# Access Compliance Report

## Public Rights-of-Way

### (Curb Ramps)

Intersection ID: 10020591	Main Street: BASIE_PARK_CT	Cross Street: N/A	Location: NE
ADA ID: 8ADCEA31268E	Ramp Type: Perp	Initial Pass/Fail: Fail	Overall Compliance: No
Codes/Mitigation Info/Possible Solution		Field Measurements/Component Compliance	
Severity Score: 10

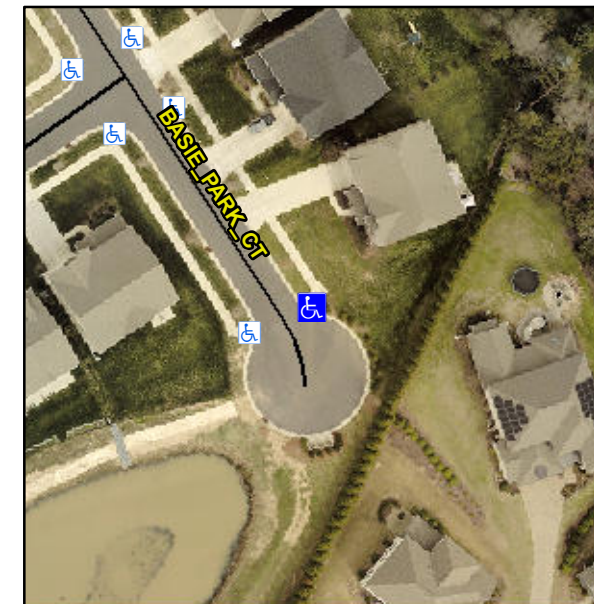
**Not Found, R304.5.1**

Compliance	Description	Data	Compliance	Description	Data
N/A	Ramp Length (in)	93.0	Yes	Ramp Slope (%)	5.7
No	Ramp Width (in)	47.0	Yes	Ramp XSlope (%)	2.7
N/A	Flare Type LT	N/A	N/A	Flare Type RT	N/A
N/A	Flare Slope LT (%)	N/A	N/A	Flare Slope RT (%)	N/A
N/A	Flare Traversable LT?	N/A	N/A	Flare Traversable RT?	N/A
N/A	Landing Length (in)	N/A	N/A	DWS Provided?	N/A
N/A	Landing Width (in)	N/A	N/A	DWS Contrast?	N/A
N/A	Landing Slope (%)	N/A	N/A	DWS Length (in)	N/A
N/A	Landing X Slope (%)	N/A	N/A	DWS Full Width?	N/A
N/A	Landing Curb? (Y/N)	N/A	N/A	DWS Offset (in)	N/A
N/A	Shared Landing?	N/A			
N/A	Gutter Ponding?	N/A	N/A	Gutter Slope (%)	N/A
N/A	Gutter Lip Ht (in)	N/A	N/A	Gutter X Slope (%)	N/A
N/A	Painted X Walk1?	No	N/A	Painted X Walk2?	N/A
	X Walk 1 Direction	To SW		X Walk 2 Direction	N/A
N/A	X Walk 1 Width (in)	N/A	N/A	X Walk 2 Width (in)	N/A
	X Walk 1 Slope (%)	0.2		X Walk 2 Slope (%)	N/A
	X Walk 1 X Slope (%)	3.0		X Walk 2 X Slope (%)	N/A

**Remove & Replace Entire Ramp.**
